Waterloo Estate (South) Concept SSDA, SSD-93222706

The following letter is provided in response to the traffic related comments received from City of Sydney Council (CoS), dated 2nd June 2026 and Transport for New South Wales (TfNSW), date 3rd June 2026.

Attachment 1. City of Sydney – McEvoy St and George St Proposal

Attachment 2. Revised Vehicle Access Location Assessments

Figure 1 Existing configuration of intersection

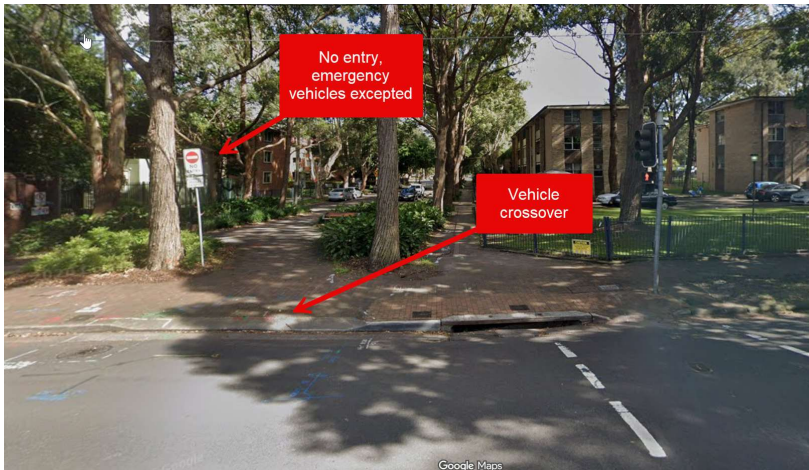
Authority	Comment	ptc. Response
CoS	George Street and McEvoy Street Intersection CoS comment – “<i>The desired future character of George Street is to be of a high street in nature. The proposed cul-de-sac design of the southern end of George Street at the McEvoy is not conducive to a local main street character and is recommended to be designed to allow for a left-in, left-out option. Further, a cul-de-sac design requires a larger turning circle, reducing the widths of footpaths and landscaping, and requires larger service vehicles including waste vehicles to complete complicated turns to return north along George Street.</i>” <i>It is acknowledged that further analysis requires to be undertaken to ensure there are no adverse safety impacts to the existing bicycle network however, appropriate traffic impact modelling should be undertaken in this application to demonstrate an acceptable impact.</i> <i>The Design Guide and accompanying documents should note the preferred option and prioritise the delivery of this design to avoid a separate approvals process in the future.</i>	The current design, as part of the CSSDA is in line with the requirements of the 2022 Design Guide, maintaining the current arrangements at the southern end of George Street. Accordingly, the proposed design is consistent with that of a high street, as envisaged by the 2022 Design Guide. The access framework also reflects the structure established in the 2022 Design Guide, with targeted refinements informed by traffic assessment and consultation with relevant authorities. The current design does not intend or allow for vehicles larger than a B99 (car) to travel along George Street South, as there are no block access driveways located on George Street South and therefore the turning circle at the southern end is designed to accommodate a B99, as per the existing arrangement. It is further noted that the City is recommending the creation of a left in and left out from George Street, to McEvoy Street. The Applicant proposes to consider this in the preparation of the Stage 1 Detailed SSDAs for Blocks 8 and 9, which includes consultation with the community in order to address any concerns that may be raised regarding this revised intersection design. In a meeting with the City in June 2026, it was discussed that TfNSW were supportive of the left in but were still reviewing the left in and left out arrangement at the subject intersection.

- T-intersection configuration (Figure 1)
- McEvoy St is a state road, George St is a local road
- Pedestrian crossings on all three legs. Cycle crossing runs parallel but separate to western pedestrian crossing.
- Northern leg of George St:
 - o cul-de-sac that is closed to general traffic
 - o allows emergency vehicles (Figure 2)
 - o has separated cycleway on the east side of road
- Southern leg of George St is:
 - o Southbound only
 - o Has separated cycleway on west side of the road
- Phasing
 - o Two phases running on 60 second cycle
 - o A phase – McEvoy St through movements, pedestrian crossing across George St, with EB right-turn into George St allowed as a filter turn
 - o B phase – both pedestrian crossings and cycle crossing across McEvoy St run

A left turn arrangement from George Street southbound into McEvoy Street eastbound is not supported as:

- 1. It is planned to transition the cycleway on George Street from the eastern side of George Street north of McEvoy Street to the western side of George Street south of McEvoy Street at the traffic lights. Allowing the left turn for drivers from George Street into McEvoy Street would impact on the transition for bike riders crossing McEvoy Street.*

- 2. Allowing the left turn for drivers from George Street into McEvoy Street would encourage rat running through the new precinct. Allowing the left turn movement for drivers would demand more time to be allocated to George Street to allow drivers to exit and not queue within the precinct.*

- 3. By allowing the left turn for drivers from George Street into McEvoy Street it would be difficult to physically restrict southbound drivers on George Street from crossing McEvoy Street and continue south on George Street. If the through southbound movement cannot be physically restricted, it would encourage more drivers to rat run through the precinct to access Green Square.*

As these discussions are ongoing there is no change proposed to the George Street McEvoy intersection as part of this RTS but is something that can be further considered with community input, in the Stage 1 detailed SSDAs. The Updated Design Guide maintains flexibility such that there is no restriction to provide this left turn at detailed SSDA stage if it is pursued. Noting the above, ptc. have reviewed the City of Sydney 'McEvoy St and George St proposal (dated July 2026) and have no concerns with the proposed layouts or intersection modelling outcomes and note the design could be utilised as the basis for any update to this intersection, should it require incorporation into any future submissions. (refer to Attachment 1 for the City of Sydney and George St Proposal) ptc. have not undertaken any additional assessment of the bicycle network, as the CSSDA submission is based on the 2022 Design Guide, which was approved as part of the 2022 Planning Proposal (PP-2021-3265). As outlined in Section 7.2.2 and 7.2.3 of the TIA, the development proposes to maintain and expand the City's regional bike network by, maintaining and upgrading the north-south separated, dual direction cycleway along George Street and implementing a new east-west, separated uni-directional cycle lanes along Wellington Street.

Figure 3 City's proposed configuration

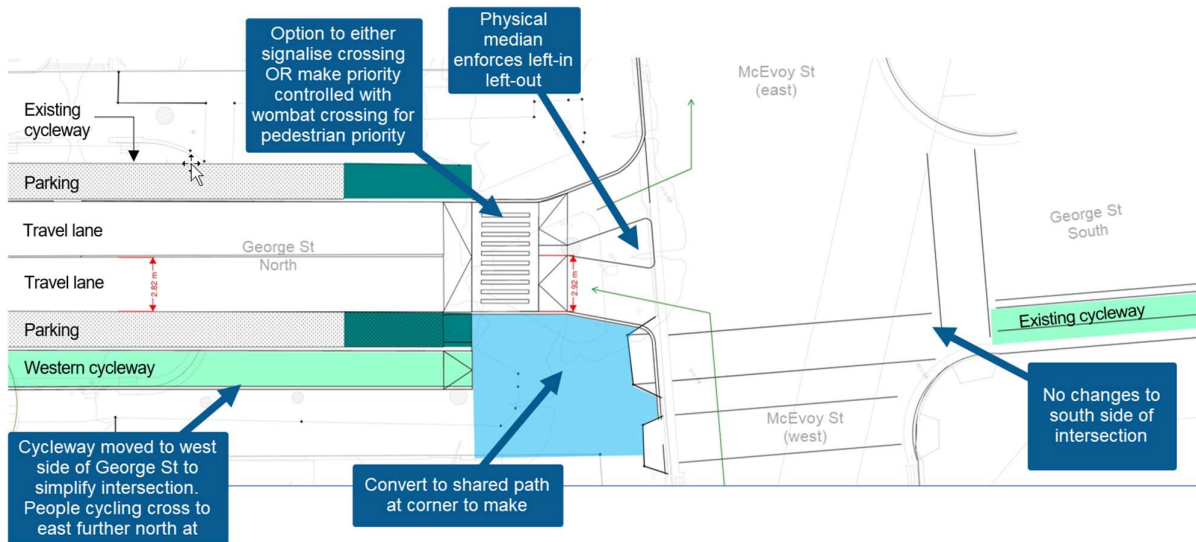
The City has developed a proposal (Figure 1) that we believe addresses TfNSW's four concerns about the left-out movement.

A physical median forces compliance with the left-in left-out restriction, and the movements to and from the northern leg can be fitted in with minimal changes to the existing phasing, minimising impacts on the performance of the intersection.

By adjusting the design of George St between John St and McEvoy St, we can keep bike riders on the west side of George St through the intersection, significantly simplifying the intersection and reducing conflict points.

The proposed design includes a physical median to prevent traffic exiting the precinct to continue straight across McEvoy St to George St south.

Figure 6 Traffic calming along internal route

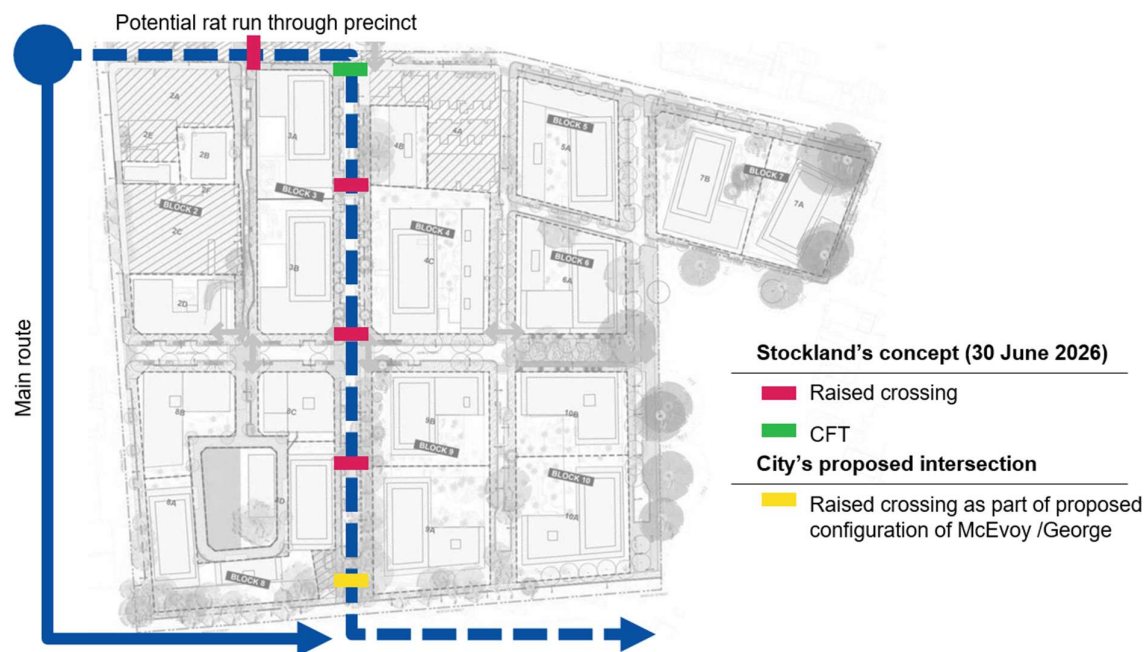
The City understands that TfNSW is concerned about southbound traffic on Botany St diverting through the precinct via Wellington St and George St to avoid the intersection of Botany St and McEvoy St.

- Traffic calming within the precinct (Figure 6) including 5-6 raised intersections or CFTs along the local route to make it slower than staying on Botany Rd and McEvoy St
- TfNSW's plans to upgrade McEvoy / Botany intersection will reduce delay and make it even more attractive relative to local roads through Waterloo South

The modelling done by Jacobs also indicates that rat running is not a major concern. Aimsun models allow traffic to choose the fastest route between set origin and destinations, and so the turn volumes above account for rat running – that is, where external traffic cuts through the precinct if it is a faster route than staying on the bordering arterial roads

These model extracts indicate that even in the PM peak, only ~150 vehicles would be using George St. We consider this a low volume of traffic and well within what is acceptable for a village high street.

DRAWING # pteT_DWG_SK31.1

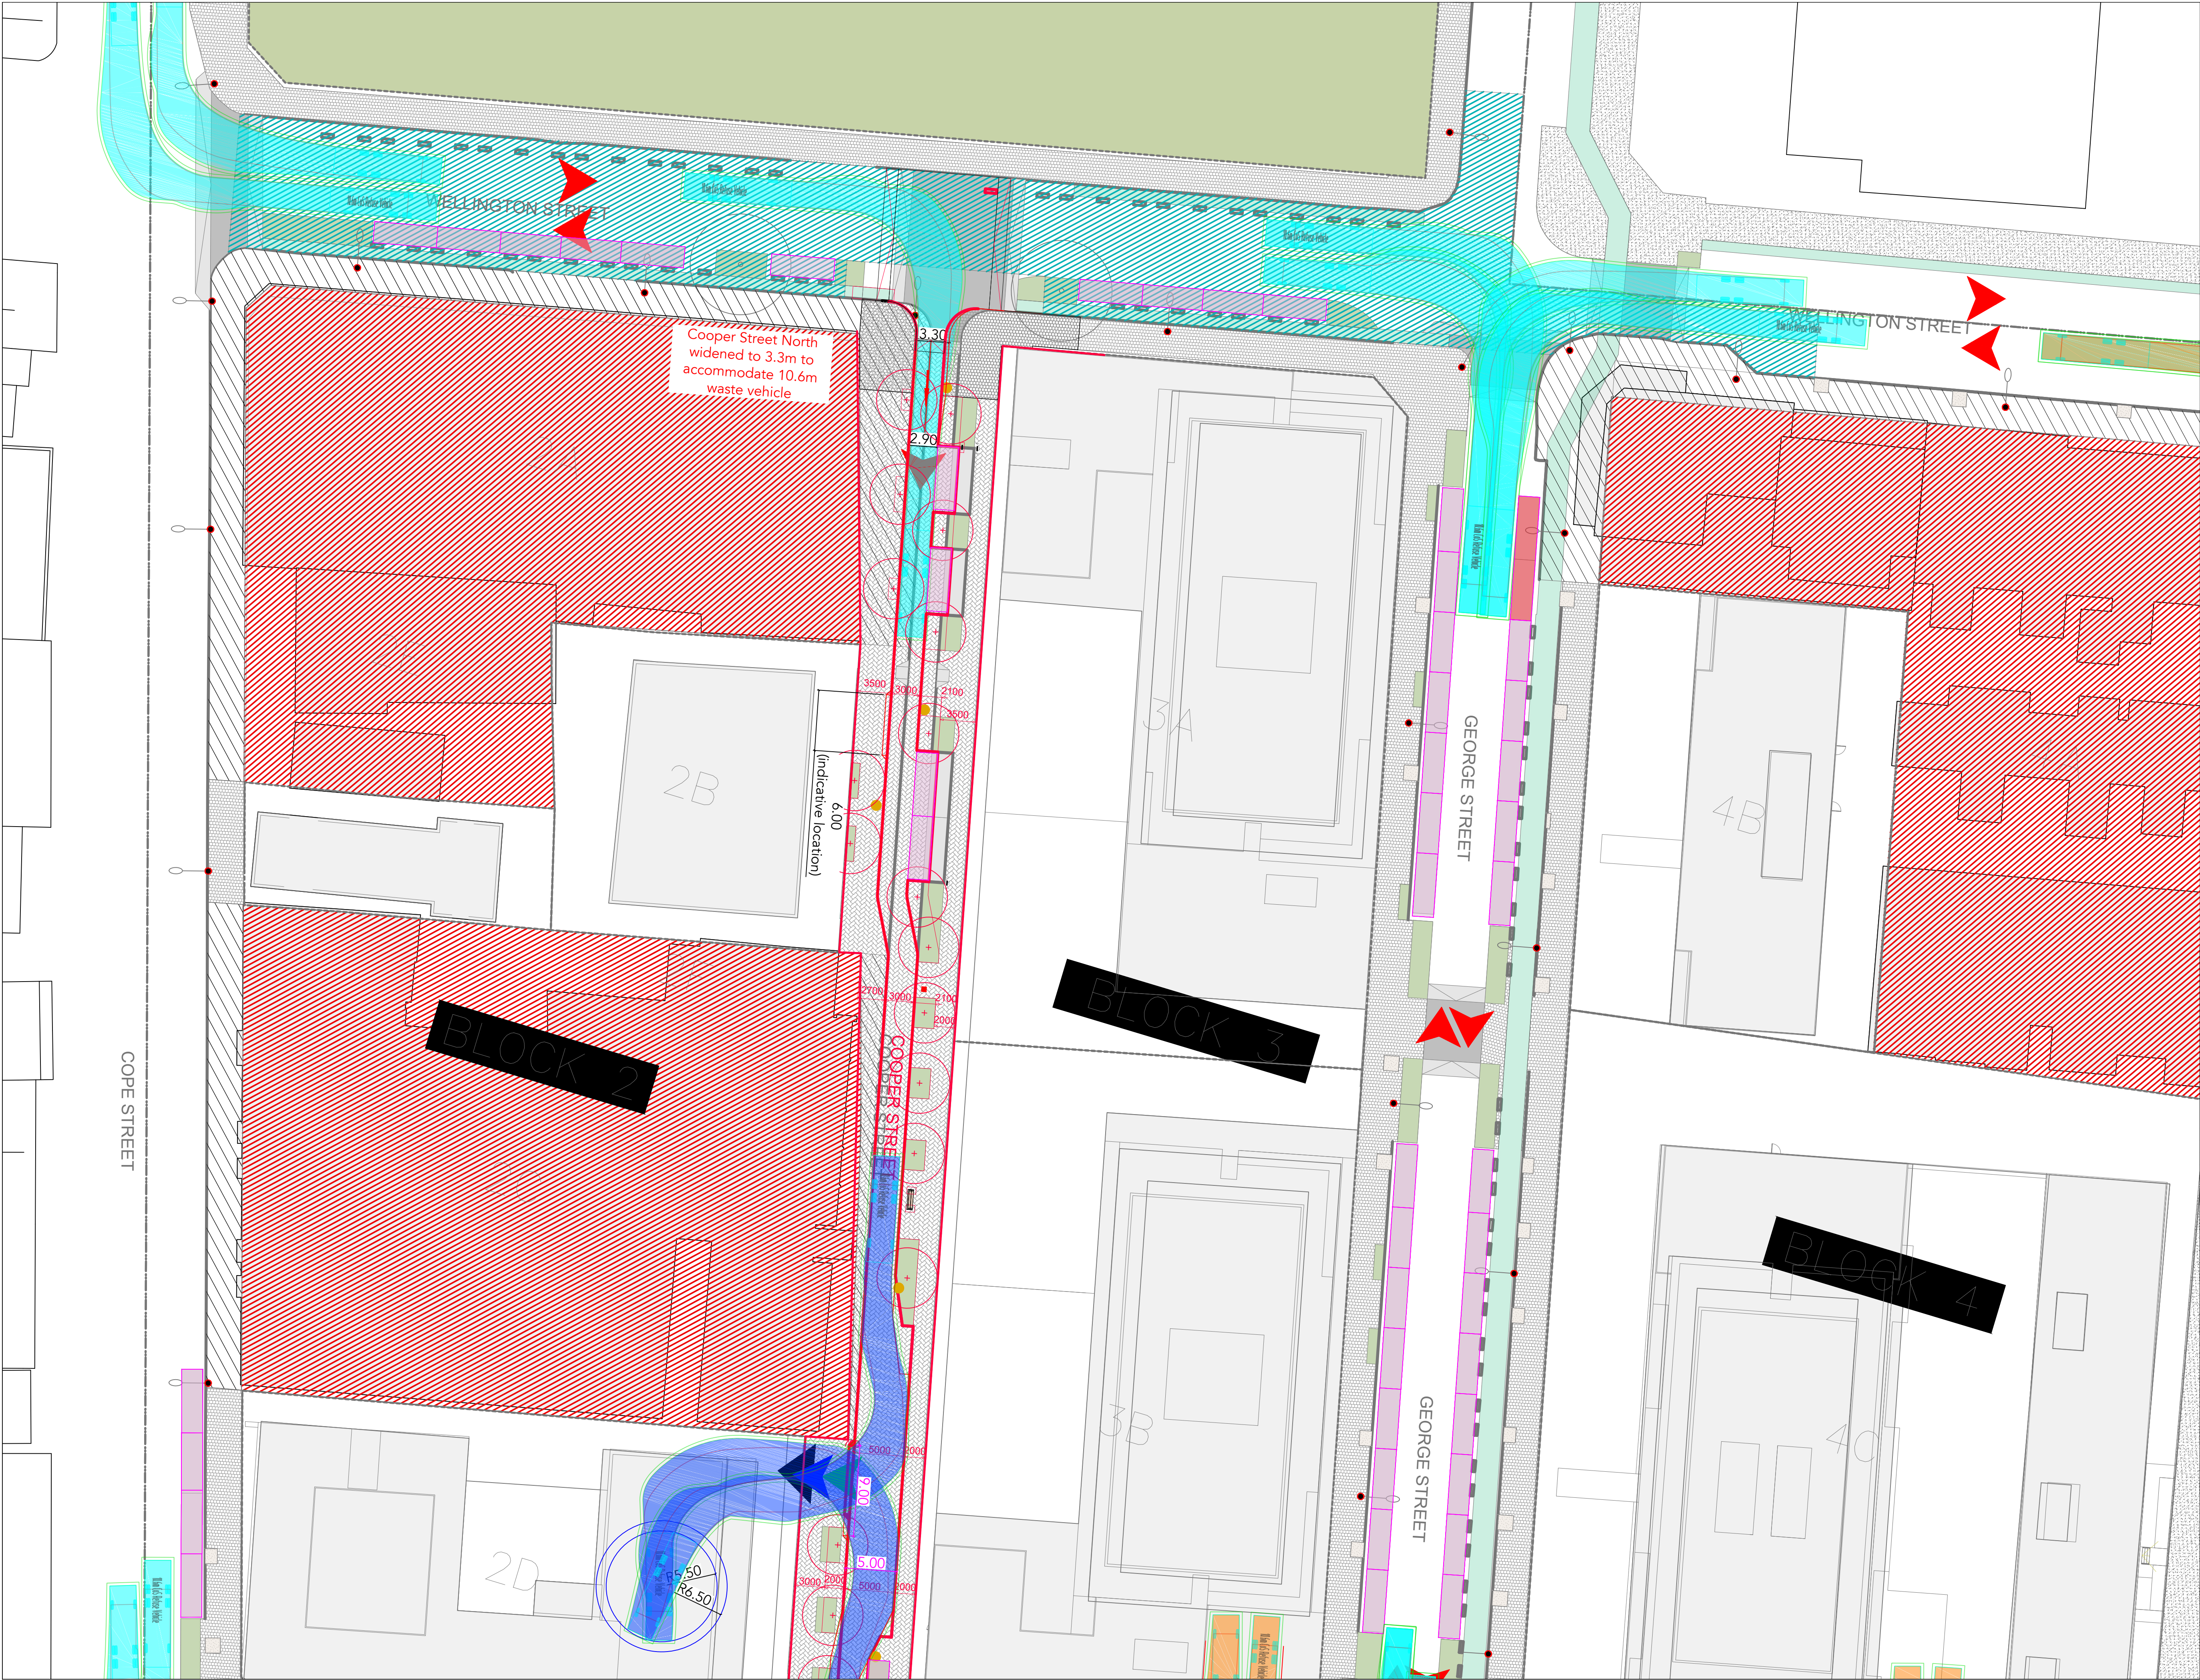
Vehicle Access Locations There are some inconsistencies between the submitted Transport Study and the Design Guide. The Transport Study does not show a vehicle access into Block 4A from West St, while the latter does. Additionally, the Transport Study does not show access into 2A, 2B or 2E, while Design Guide shows two access points. This should be clarified in documentation. Further, the Transport Study indicates that driveways are much wider than driveway widths recommended by the City. Street design should prioritise pedestrian safety and the driveway widths should be reduced as much as possible, preferably to a maximum of 6m. This can generally be achieved by: • Two-way yield driveway: Combining into a single lane serving both entry and exit, with movements controlled via signal. Entering vehicles given priority, while exiting vehicles can wait in a waiting bay. AND/OR • Allowing entering and exiting vehicles to cross the centreline, which allows them to swing wider and enter the driveway from a more perpendicular angle. Vehicle entries should generally be designed in accordance with the relevant provisions of the SDCP 2012, including distance from other driveways and	In response to the comments raised, ptc. have reviewed and modified the block accesses as follows (refer to Attachment 2 for updated Vehicle Access Location Assessment): • Block 2B – Indicative 6m wide driveway shown • Block 2D – 9m wide driveway (due to narrowness of Cooper Street) • Block 3 – Driveway provided 6.5m wide, 8.5m offset from George St TP (min 6m allowed in accordance with AS2890.1 Figure 3.1). and 3.5m from Block 8 service vehicle driveway (set by building form) • Block 4 – Single driveway, reduced to 6.5m • Block 5 – Location determined by building form (driveway width of 9m required due to narrowness of West Street) • Block 7 – 7m wide driveway angle of Pitt St, located 6m from Kellick St TP in accordance with AS2890.1 Figure 3.1 • Block 8 – 2 basement driveways now provided (both 6m wide), 1 service vehicle driveway (6m wide). No access or egress to Cooper Place

<table><tr> <th>Block</th><th>Recommendation</th><th>Notes</th></tr><tr> <td>Block 3</td><td>Offset from Block 8 access location</td><td>Vehicle access is not to be located opposite a busy driveway for a distance of 5m beyond the alignment of the driveway edges or within 15m of the alignment of an intersection where the proposed vehicle access is to be used by service vehicles</td></tr><tr> <td>Block 4</td><td>Consolidate into one location OR narrow and separate driveways</td><td>Block 4 shows two access points: one for service vehicles (10m) and the other for residential parking (7m). These are both excessive and disrupt the pedestrian experience along the footpath. Update to either combine into one driveway or narrow both driveways to 5m and 6m respectively.</td></tr><tr> <td>Block 8</td><td>Entry from John: Consolidate into one driveway and offset from Block 3 access location Exit to Cooper Place: Update Design Guide to show this</td><td>Figure 50 of Transport Study shows that Block 8 relies on vehicle exit onto Cooper Place, however Design Guide only shows vehicle access from John St. The exit onto Cooper Place may be supported but only if safe to do so and in a forward direction. Further confirmation is required.</td></tr></table>
